RDM # 3 - Dewpoint South – Dolsontown Road Town of Wawayanda, Orange County, New York Colliers Engineering & Design Project No. 20006912E

The following items are in response to comments contained in the Creighton Manning Engineering; LLP (CM) letter dated August 1, 2023. Also enclosed here for your convenience and reference is a copy of our August 3rd letter (the "August 3rd Letter"), enclosed as **Attachment A**.

CME's specific comments are restated and addressed below:

- West Access SD-1A
- Caskey Lane Sheet 1 of 3

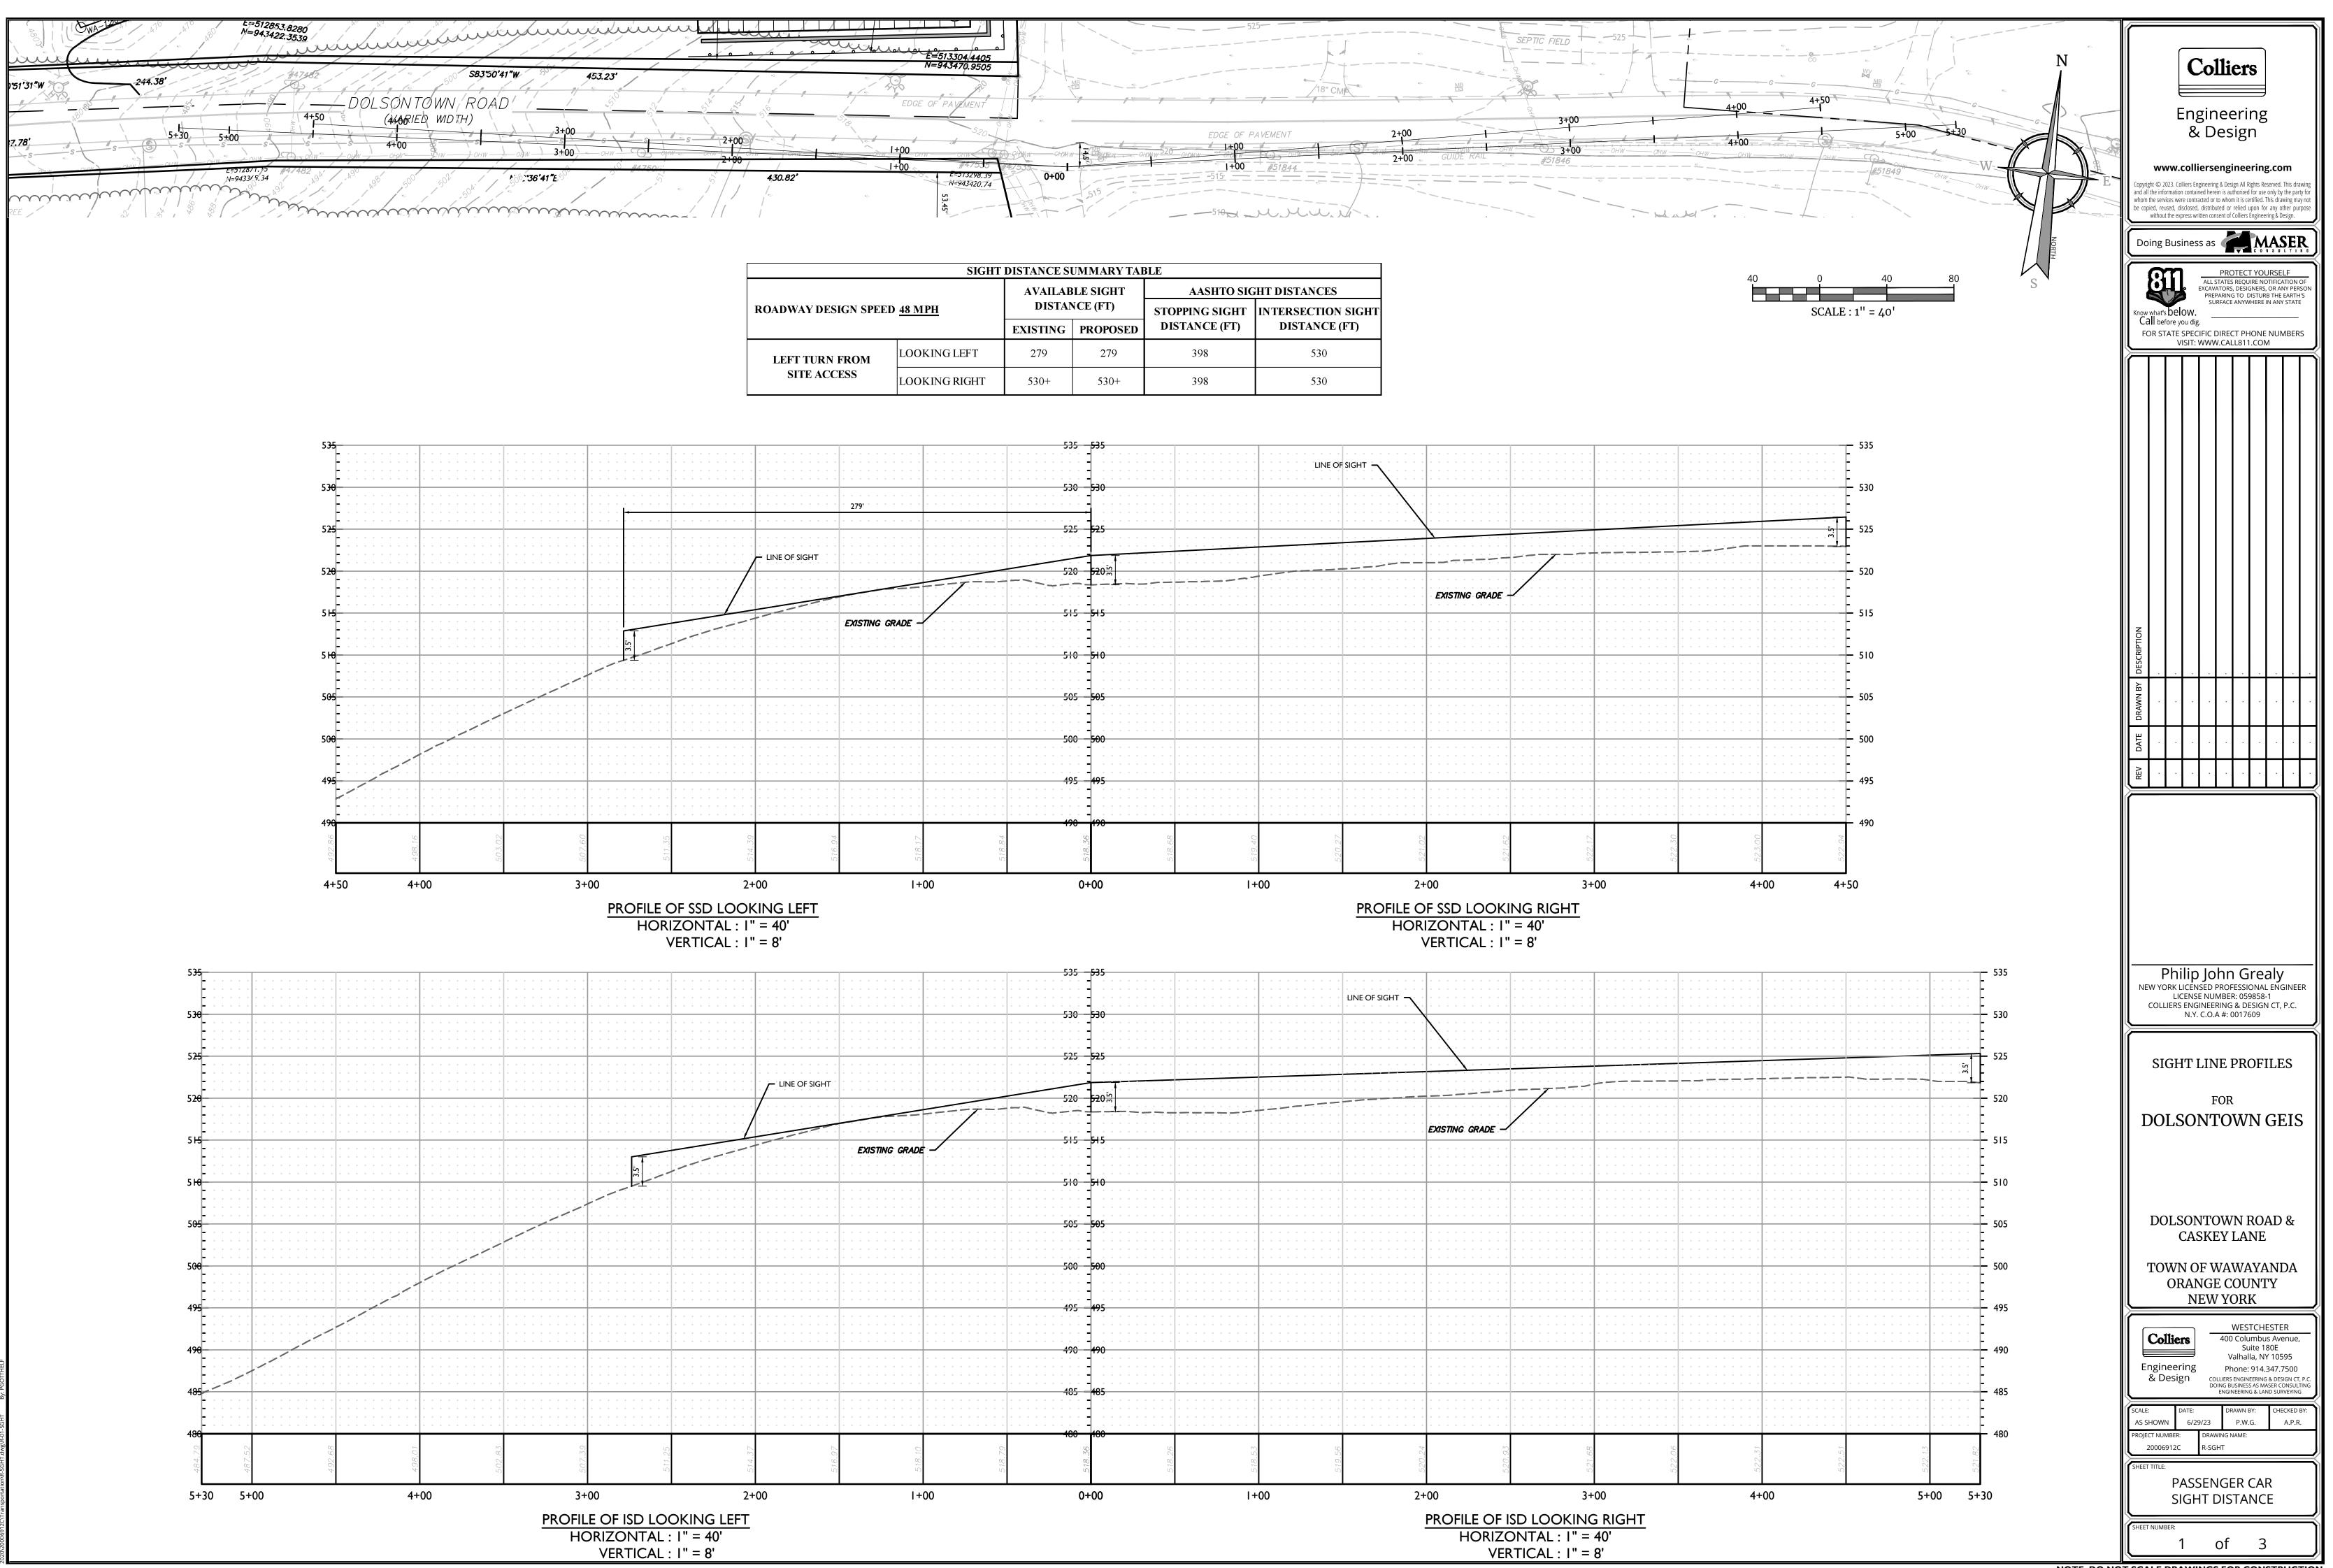
1. Establish sight distances to/from the west driveway.

Response: The sight distances were established for the west access as part of the GEIS Process. We are supplying them again with this submission on Sheet SD-1A. See Attachment C.

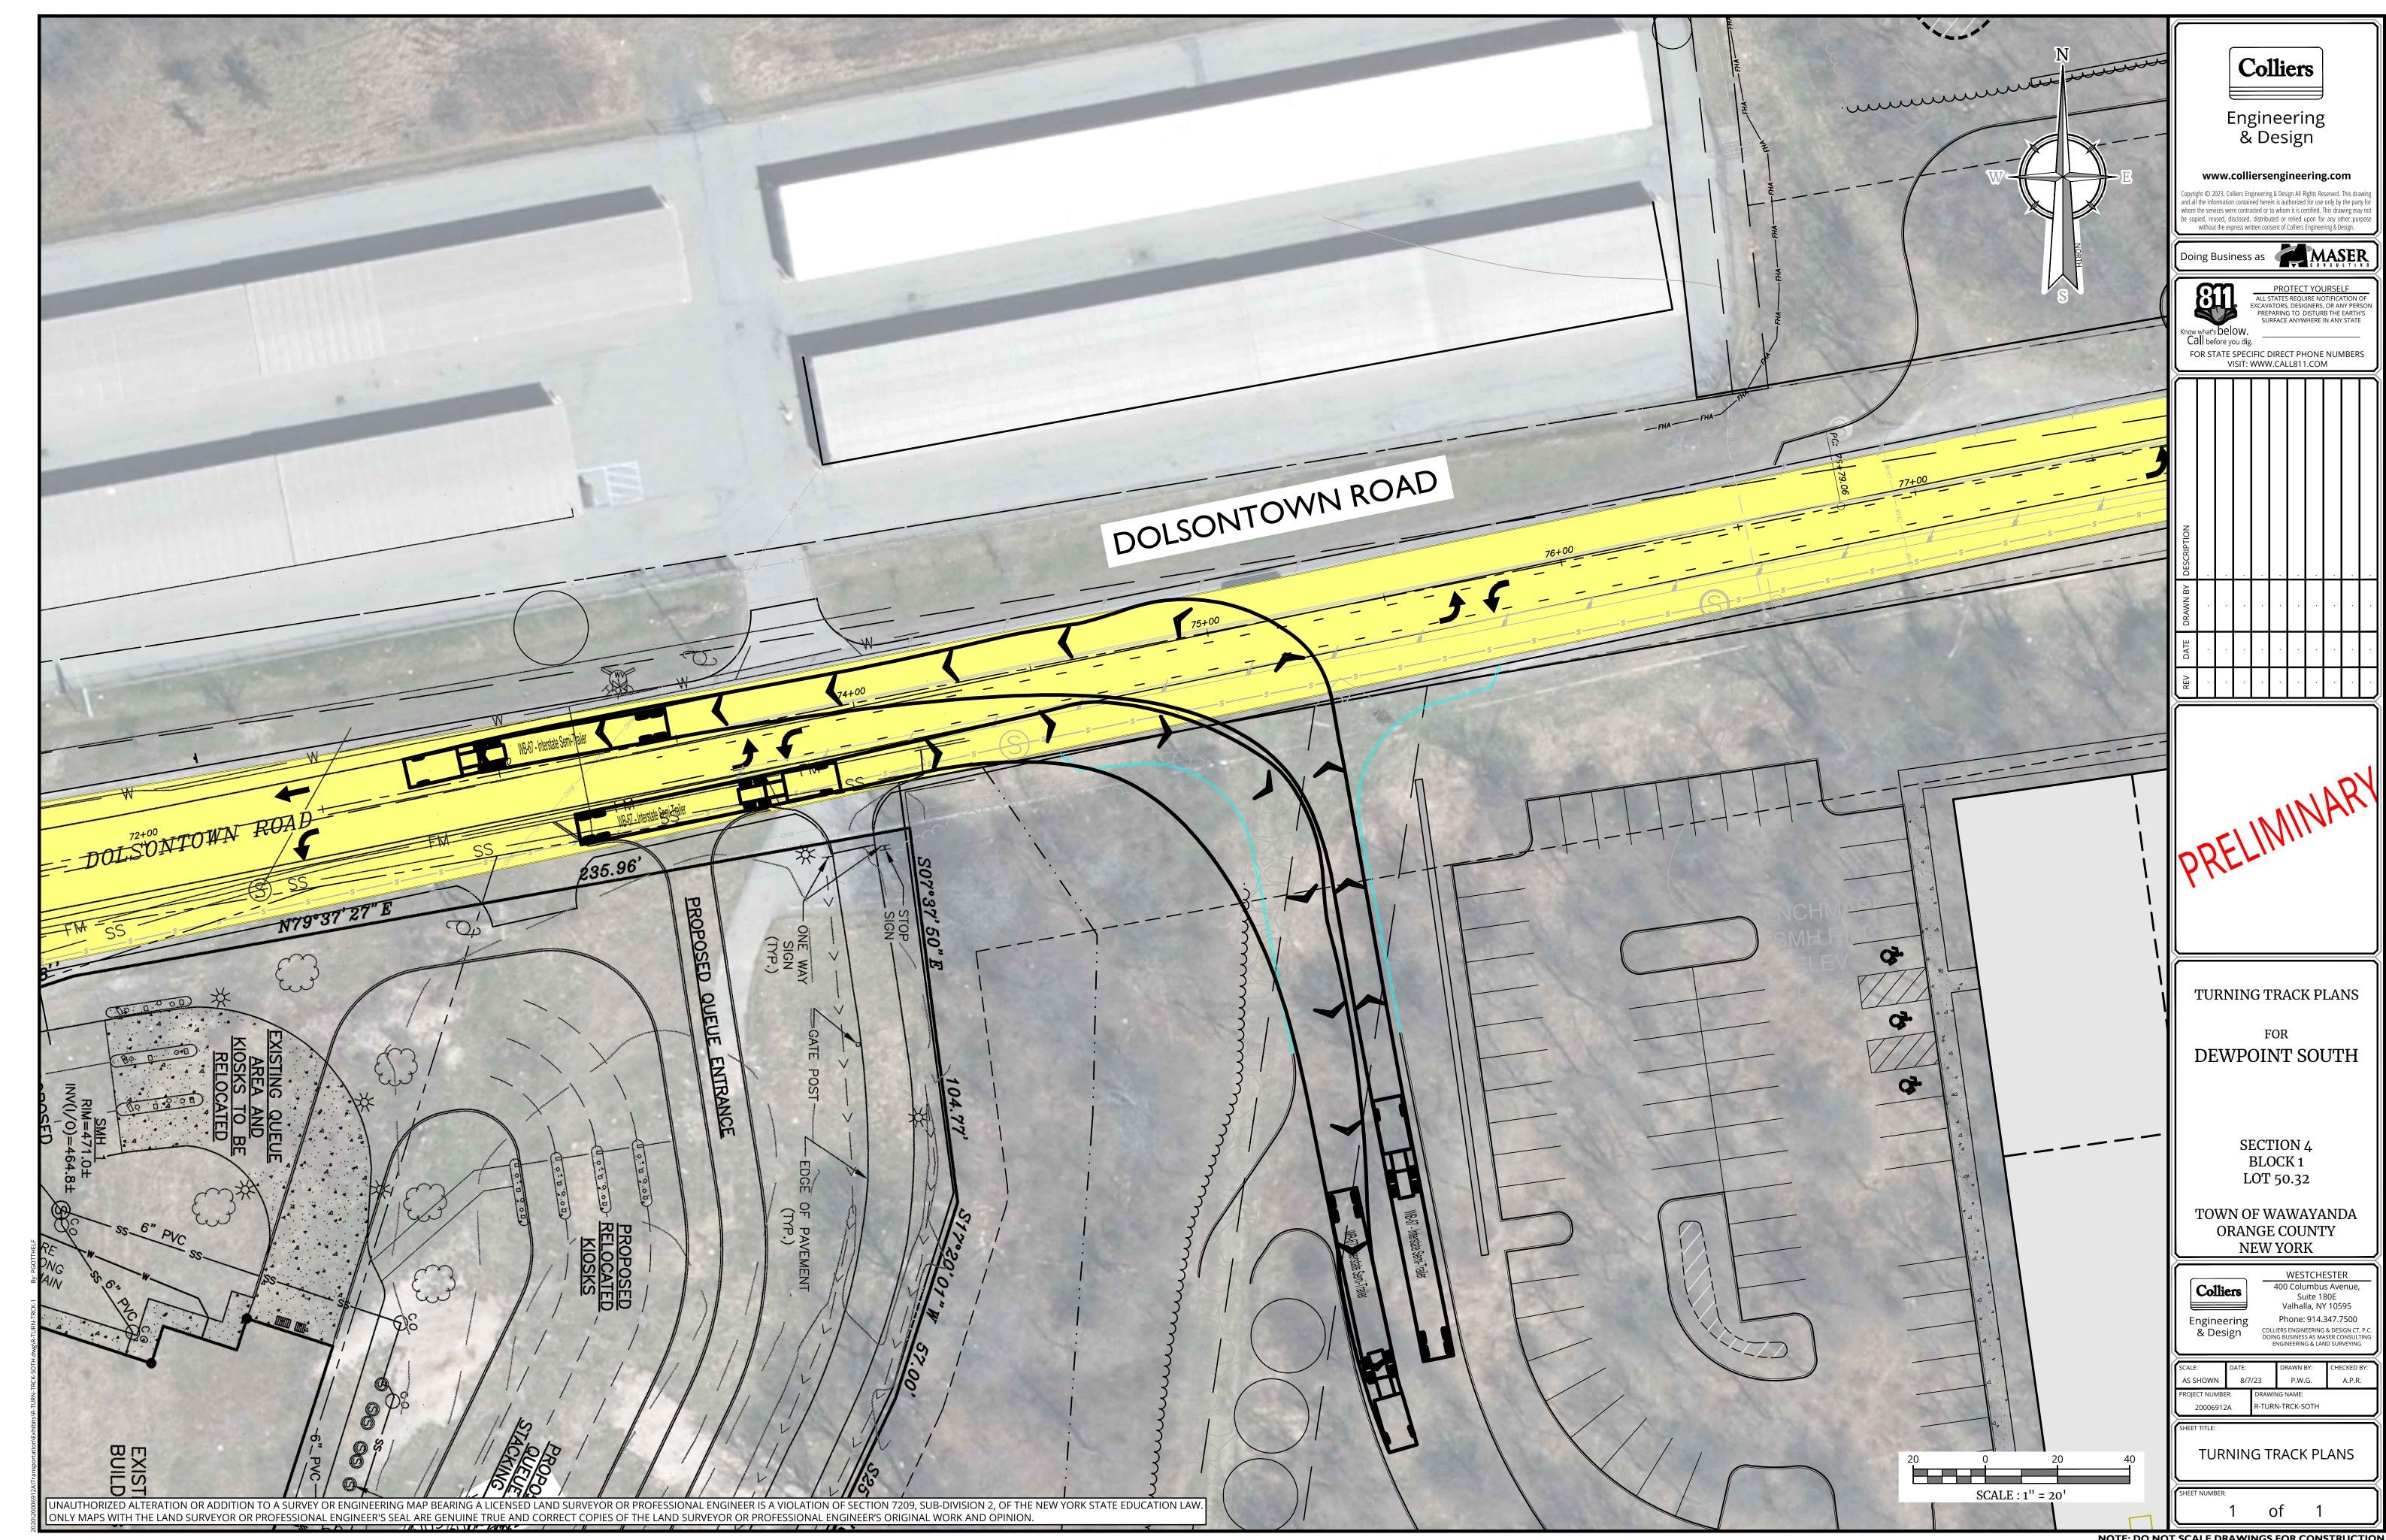
- 2. Establish sight distances to/from the Caskey Lane intersection.
 - a. A sight distance exhibit was submitted as part of the Simon (RDM #6) project. That exhibit would also be applicable with this application and should be submitted for the record.

- b. The Simon exhibit suggests that the intersection sight distance looking right (west) [sic] is adequate. Was the grade of Caskey Lane taken into account? The uphill grade for vehicles exiting Caskey Lane will require longer sight distances.

- c. The sight distance looking left (east) [sic] is listed at 279 feet, whereas the AASHTO guideline is 530 feet (excluding any grade consideration on Caskey Lane) based on the observed 85th percentile speed 48 mph.

- 3. We have significant concerns regarding sight distance at Caskey Lane. The condition exists today but the only uses on Caskey Lane are two single family homes. Simon proposes 221 parking spaces to use Caskey Lane and Dewpoint South proposes another 94 spaces. The Simon exhibit suggests that stopping sight distances can be met if the speed limit is reduced, a recommendation that originated with the 1081 Dolsontown project. Given the amount of traffic proposed to use Caskey Lane, stopping sight distance should not be the minimum threshold to meet. Further, it is unlikely that NYSDOT will lower the speed limit until projects are built and conditions warrant such. Even if the speed limit is preemptively lowered or lowered contingent to the construction of one or both of these projects, achieving intersection sight distances should be the goal. Additional discussions on the matter will be necessary.

- Response: We have included herein the sight distance evaluation that was submitted as part of the Simon (RDM #6) project as this is proposed as a shared access, to be made part of this project's record as well. See Sheet 1 of 3 in Attachment C.

- Response: We anticipate that any improvement to Caskey Lane in terms of pavement structure to support more numerous vehicles will include a modification of the Caskey Lane approach grade to Dolsontown Road (to reduce the uphill grade) such that no adjustment for grade to Stopping Sight Distance will be necessary. With respect to Intersection Sight Distance, please see the discussion in response to item 3 below. The stopping sight distance to the west will be achieved with a speed reduction. As was initially noted following the development of a Traffic Impact Study for the 1081 Dolsontown Road project, and as most recently discussed in our July 13th, 2023 letter to the Town Board, the existing roadway design has limited vertical Stopping Site Distance that supports travel speed of only 35 miles per hour. Automatic Traffic Recorders placed on Dolsontown demonstrate that the 85% speed on Dolsontown Road is 48 MPH, above the limit of 45 MPH. This is an existing condition that merits reduction of the speed along Dolsontown Road to 30 to 35 MPH, regardless of whether any proposed projects are constructed.

Response: Comment noted. It is the view to the west that is limited. Please see the discussion above in response to item 2(b) and below in response to item 3 relative to the proposed speed reduction. Such speed reduction will both address the existing condition of inadequate vertical Stopping Site Distance (the observed 85% speed is 48 MPH, with vertical Stopping Site Distance that supports travel speed of only 35 miles per hour) and allow for the recommended Stopping Site Distance looking west from Caskey Lane onto Dolsontown Road.

- Response: We appreciate and agree that achieving Intersection Sight Distance (ISD) is a desirable goal, but the volume of traffic attributable to a particular intersection does not bear on the importance of this goal.

In many instances achieving ISD is not possible because of changes in existing vertical and horizontal alignments. This is generally acceptable, because the intent of the intersection sight distance is to limit reductions in speed to no more than 70% of the initial speed; a comfort/convenience value.

This is distinguished from Stopping Site Distance (SSD), which is safety related. Achieving the SSD indicates that vehicles have the ability to perceive; react and stop before an impact occurs, even in wet pavement conditions. As long as the SSD is provided, the geometrics are considered as safe.

As set forth above, there is currently inadequate vertical Stopping Site Distance on Dolsontown Road to support existing speeds. This can be addressed by the reduction of the speed along Dolsontown Road from 45 MPH to 30 - 35 MPH. If this is implemented, the existing safety concern will be addressed, and further, SSD will be met for this project.
